MASTER DEVELOPMENT PLAN (MDP) NO: 868A

ESCONDIDO NORTH SUBD.
MASTER DEVELOPMENT PLAN
MDP #868A

Re: **Escondido North Subdivision (Amended)** **MDP # 868-A**

The City Staff Development Review Committee has reviewed Escondido North Subdivision Master Development Plan **MDP # 868-A** previously known as Sonoma Subdivision MDP. Please find enclosed a signed copy for your files. Your plan was approved for acceptance, however please note the following:

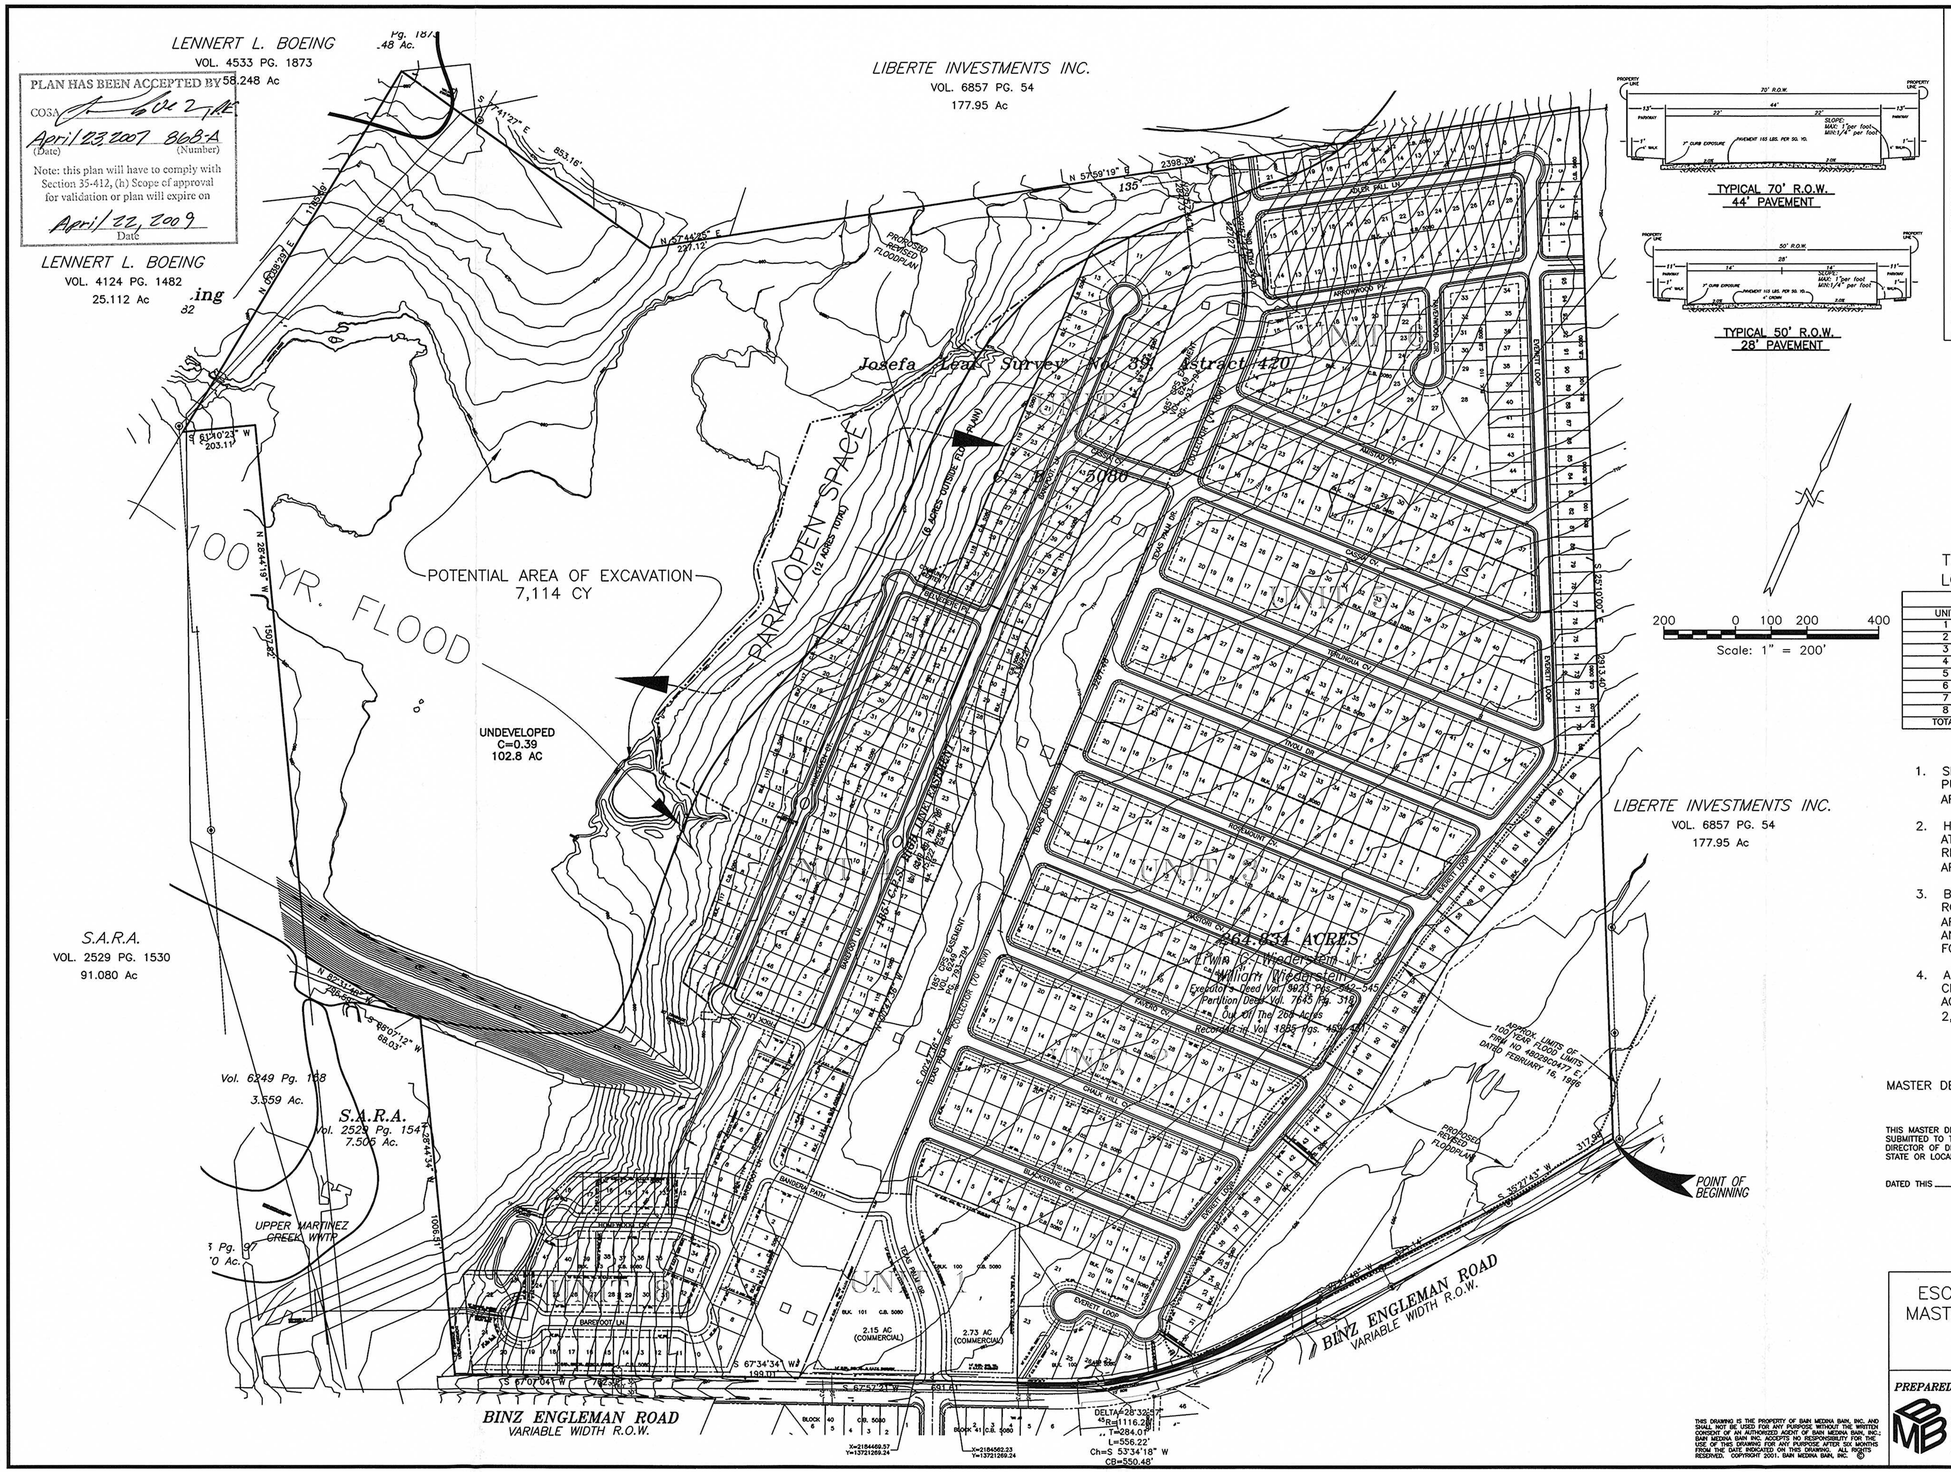
In consideration of public safety and convenience, excessive grades due to topography should be avoided in street layouts and arrangements. Any access and R.O.W. issues along state facilities will need to be resolved with the **Texas Department of Transportation (TXDOT)**. For information about these requirements, you can contact TXDOT at 615-5814.

- The developer shall be responsible for providing a right-turn deceleration lane (295' with

taper) as well as left turn lanes (200' storage and 100' taper) for Binz-Engleman at Texas Palm Drive (entrance), as it relates to the submitted TIA traffic counts (Unified Development Code (UDC) - 35-502 (a)(7), subsection C.

- The construction of Unit-4 will overburden Bandera Path with over 1,000 vpd. Unit-7 shall be submitted prior to, or in conjunction with Unit-4, with the secondary entrance across the CPS easement.

1. An eastbound left turn and a westbound right turn deceleration lane on Binz Engleman at Texas Palm.

2. Secondary access to the proposed collector roadway will be required prior to approval of any phase exceeding 125 lots.

- This project will be subject to the Streetscape standards and 2003 Tree Preservation ordinance.
